SUBJECT: ISSUANCE OF AMENDMENT NO. 7 TO FACILITY OPERATING LICENSE  
NO. NPF-63 - SHEARON HARRIS NUCLEAR POWER PLANT, UNIT 1,  
REGARDING TECHNICAL SPECIFICATIONS RELATING TO CYCLE 2  
OPERATION (TAC NO. 67089)

Amendment No. 7  
License No. NPF-63

SAFETY EVALUATION BY THE OFFICE OF NUCLEAR REACTOR REGULATION  
SUPPORTING AMENDMENT NO. 7 TO FACILITY OPERATING LICENSE NO. NPF-63  
CAROLINA POWER & LIGHT COMPANY, et al.  
SHEARON HARRIS NUCLEAR POWER PLANT, UNIT 1  
DOCKET NO. 50-400

**FIGURE 2.1-1  
REACTOR CORE SAFETY LIMITS - THREE LOOPS IN OPERATION**

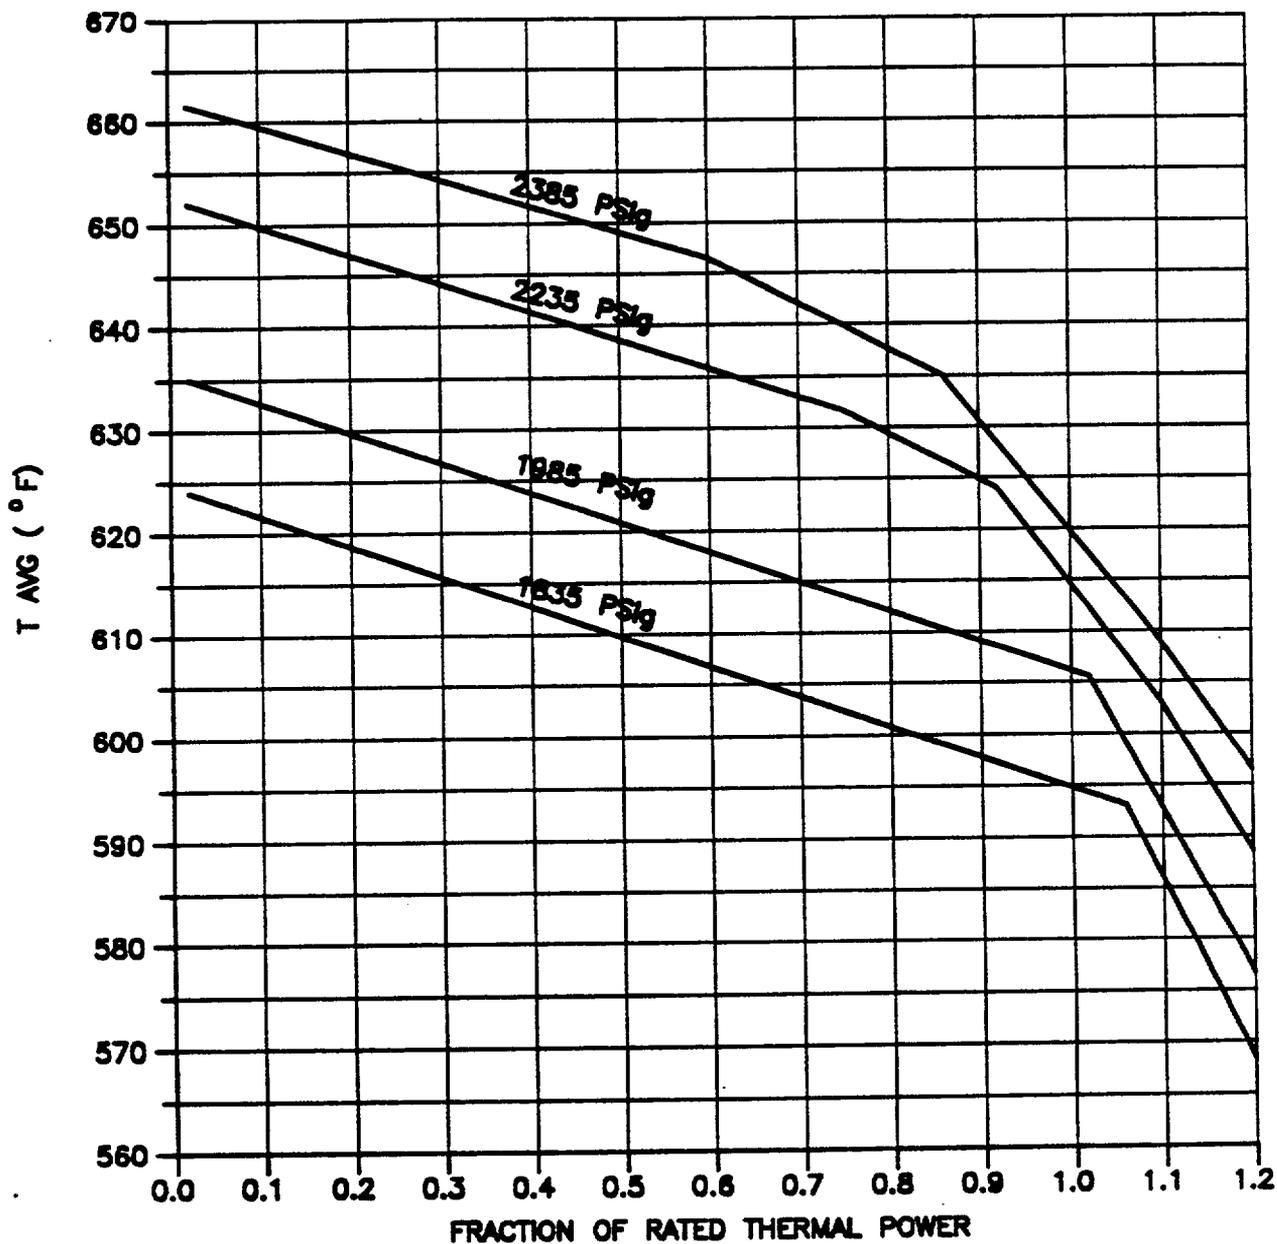
flexibility at reduced power levels. The criterion for the acceptability of this change is the value of the minimum DNBR to be no less than  $>1.30$ . The core limit curves in TS Fig. 2.1-1 represent thermal power, RCS pressure and average temperature for core states for which minimum departure from nucleate boiling ratio (MDNBR)  $>1.30$ . The full power value of  $F_{\Delta H}$  remains the same. Therefore, the LOCA analyses presented in the FSAR, which assume 100% power operation, are not affected. The proposed change does affect event analyses at a fractional power level and events which rely on  $OT\Delta T/OP\Delta T$  trip function for protection. The existing setpoints were compared to the revised core limits with the 0.3  $F_{\Delta H}$  multiplier, and it was determined that the existing setpoints envelope the new limits. Therefore, the non-LOCA events analyses presented in the FSAR are still valid.

- (a) TS 3.2.3.6, the equation used to determine  $F_{\Delta H}$ ; and
- (b) TS Figure 2.1-1, core limit curves.

The discussion in Section 2.3.1 indicates that the proposed change is enveloped by the existing LOCA and non-LOCA analyses in the FSAR and, therefore, are acceptable.

FIGURE 3.1-1  
SHUTDOWN MARGIN VERSUS RCS BORON CONCENTRATION  
MODES 3, 4, AND 5

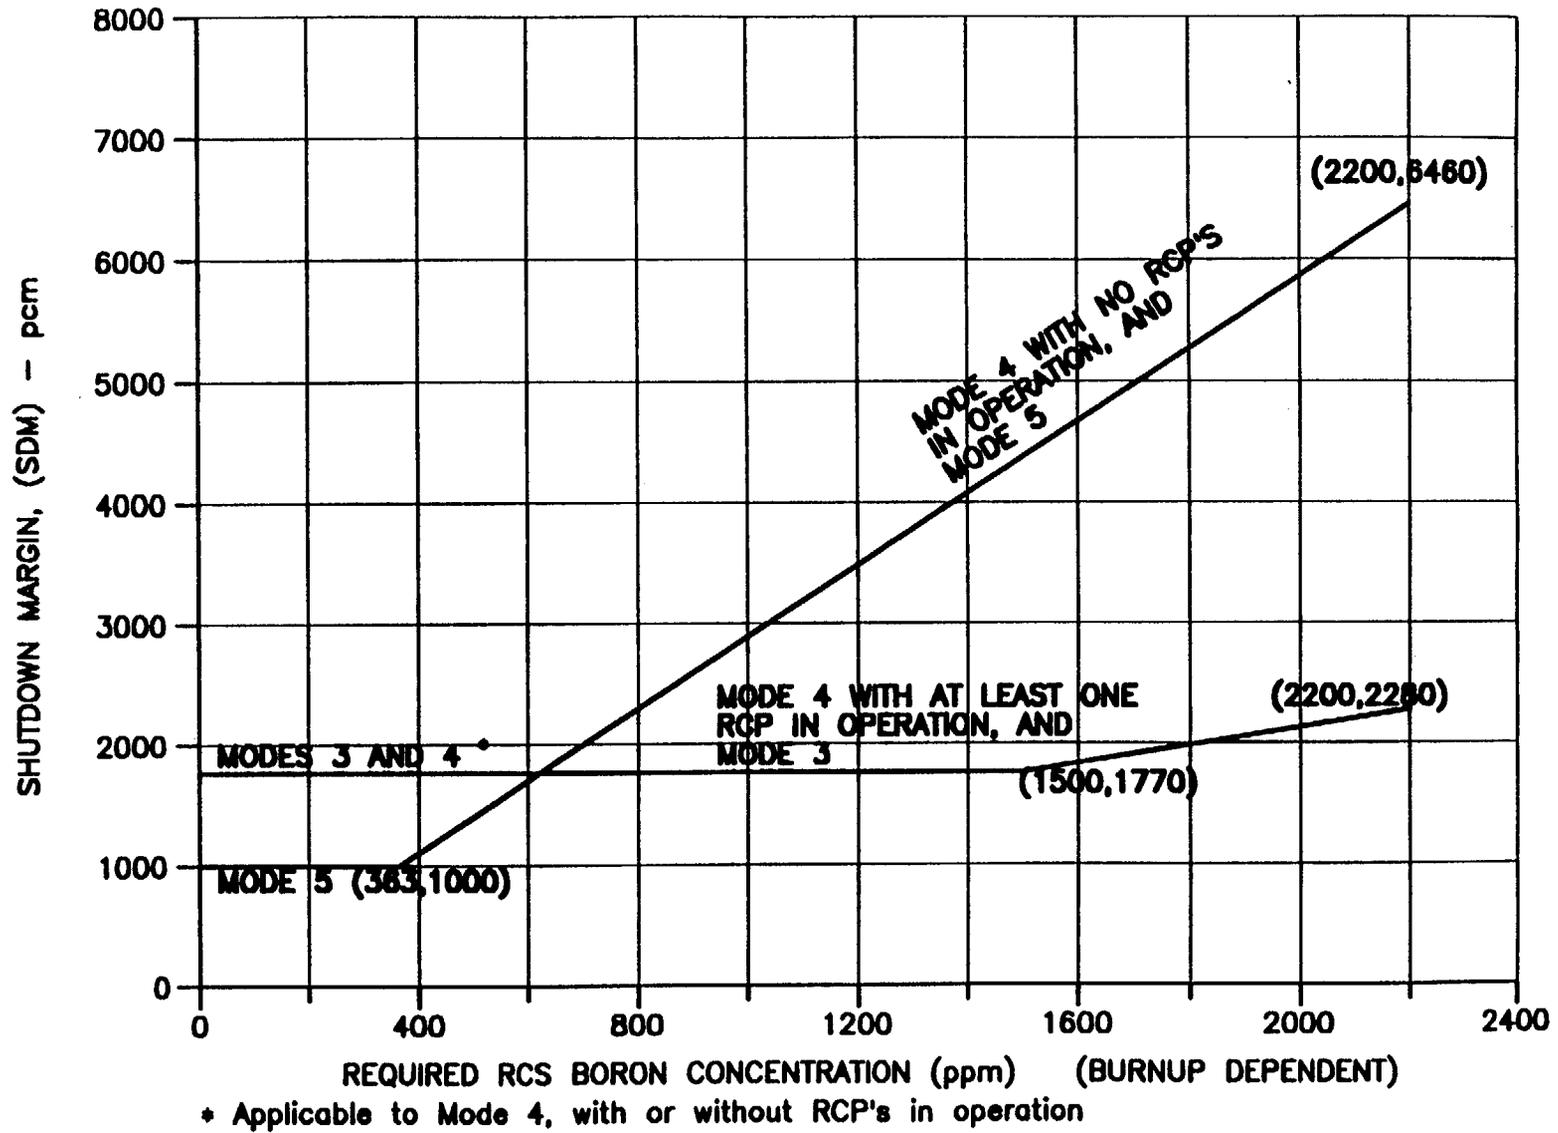
The proposed amendment modifies TS 3/4.1., Shutdown Margin, from a fixed to a variable shutdown margin requirement. Due to increased enrichment and low leakage loading configuration, Shearon Harris will have higher shutdown margin requirements at the beginning of Cycle 2 (BOC-2) than the corresponding value at BOC-1 (Ref. 2).

coolant system cooldown. The variable part arises from the requirements of an inadvertent boron dilution event, where the shutdown margin is varied as a function of primary boron concentration, to guarantee a minimum of 15 minutes for operator action prior to loss of shutdown margin. The existing TS require the shutdown margin to be fixed at the higher BOC value throughout the cycle, even though the required shutdown margin decreases with core burnup. The proposed change alleviates this condition by introducing a variable shutdown margin for operating modes 3, 4 and 5 to take credit for reduced shutdown margin toward the end of cycle. Rod insertion limits (in TS 3.1.3.6) ensure adequate negative reactivity to take the reactor subcritical from modes 1 and 2. Therefore, the variable shutdown margin is not applicable in these modes.

The proposed reduction in shutdown margin impacts only the inadvertent boron dilution, which has been reanalyzed. It was determined that the proposed sliding shutdown margins maintain at least 15 minutes from alarm indication to loss of shutdown margin, as required by section 15.4.6 of the Standard Review Plan. The shutdown margin requirements for modes 1, 2, 3 and 4 remain equal to or greater than those in the existing TS, and the main steam line break event is not affected by the revision of the shutdown margin requirements. Therefore, the proposed revisions to TS 3/4.1.1.1 and 3/4.1.1.2 do not involve a reduction in the margin of safety.

**FIGURE 3.1-2  
ROD GROUP INSERTION LIMITS VERSUS THERMAL POWER  
THREE-LOOP OPERATION**

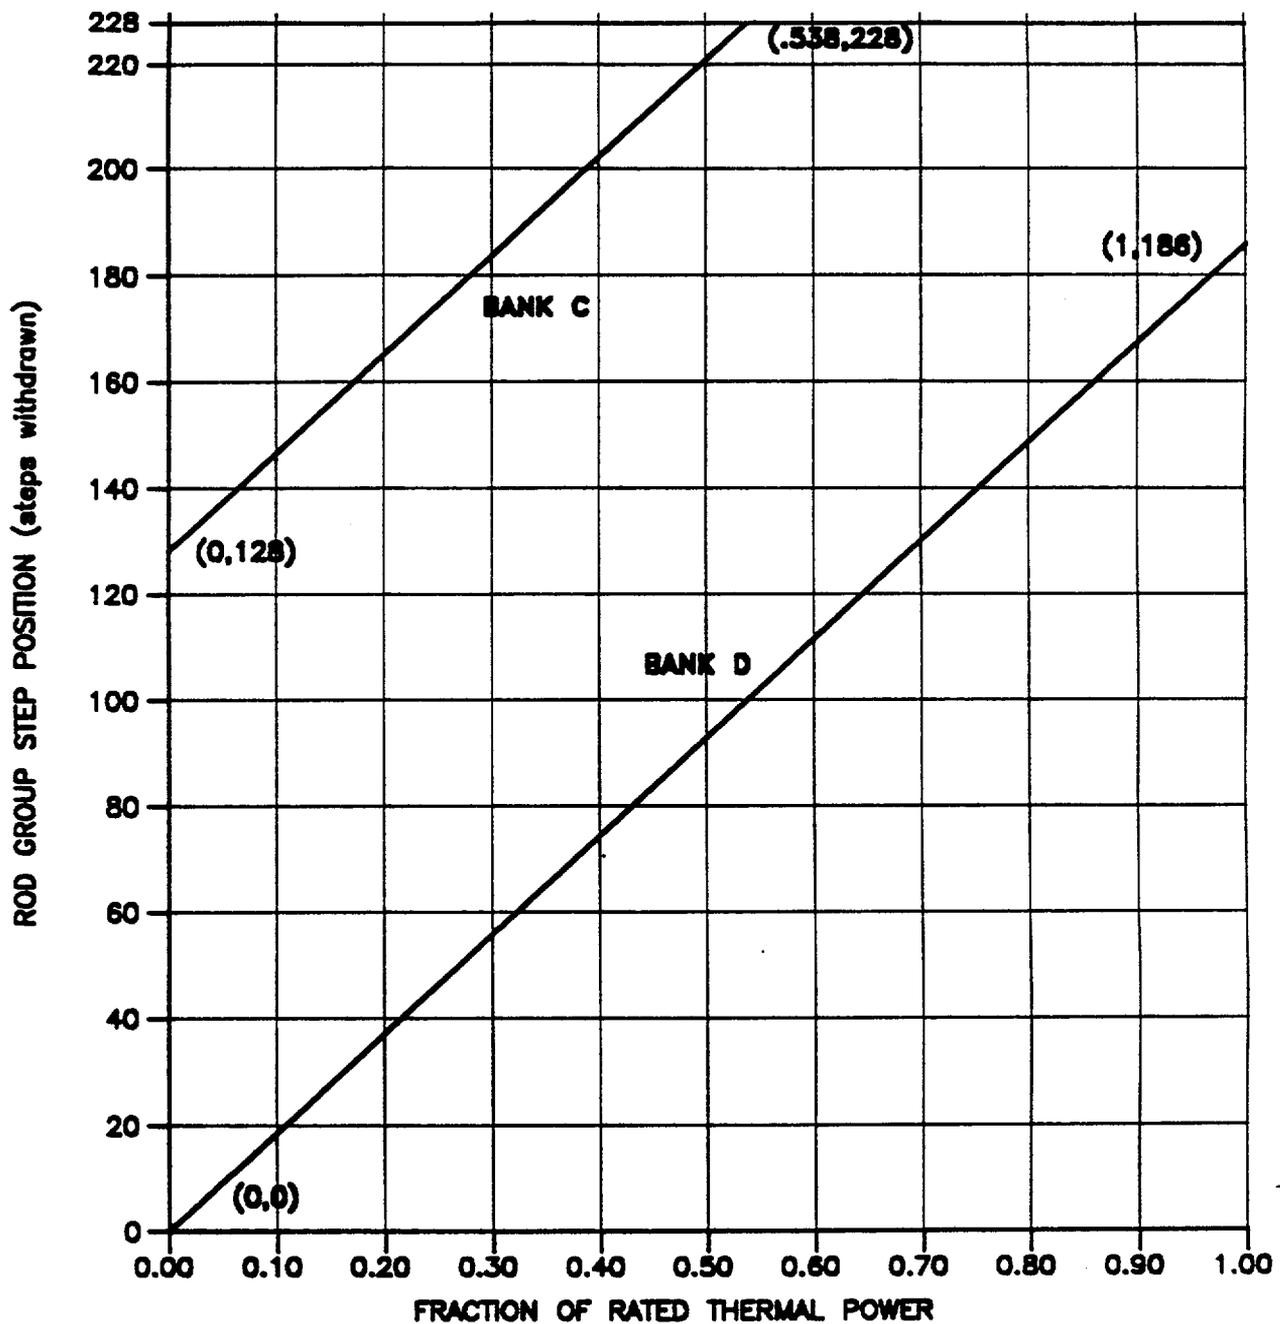
In summary, we find that the proposed control rod Bank-D reconfiguration is necessary for the intended operation of Cycle 2 in Shearon Harris; and the effects of the proposed insertion limits are within the FSAR analyses limits and are acceptable. Therefore, the proposed TS change in Fig. 3.1-1 is acceptable.

FIGURE 3.2-2  
 $K(Z)$  - LOCAL AXIAL PENALTY FUNCTION FOR  $F_0(Z)$

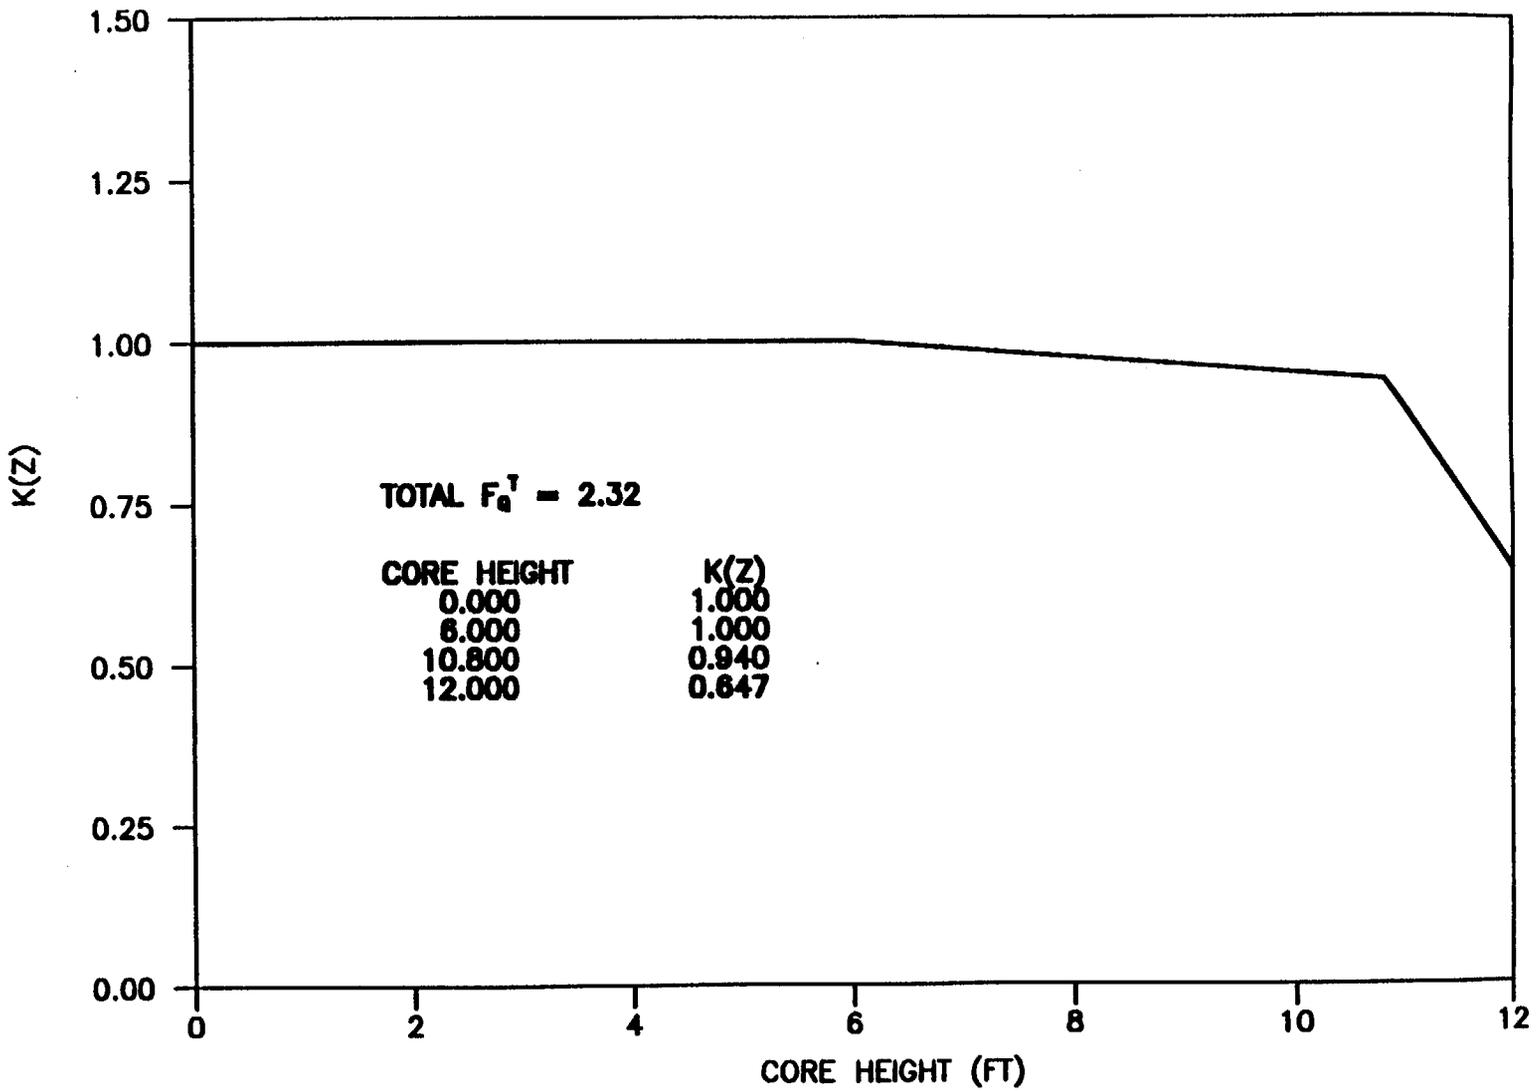
- (a) TS 3.2.2, increasing the heat flux hot channel factor;
- (b) TS Fig.3.2.2, revising the local axial penalty function  $K(z)$ ;
- (c) TS 3/4.2.1, replacing CAOC with RAOC/Base Load operation;
- (d) TS 4.2.2.1 surveillance, replacing  $F_{xy}$  with  $F_Q$ ;
- (e) TS Table 2.2-1, revising the  $f(\Delta I)$  function; and
- (f) TS 6.9.1.6, delineating the contents of the revised peaking factor limit report.
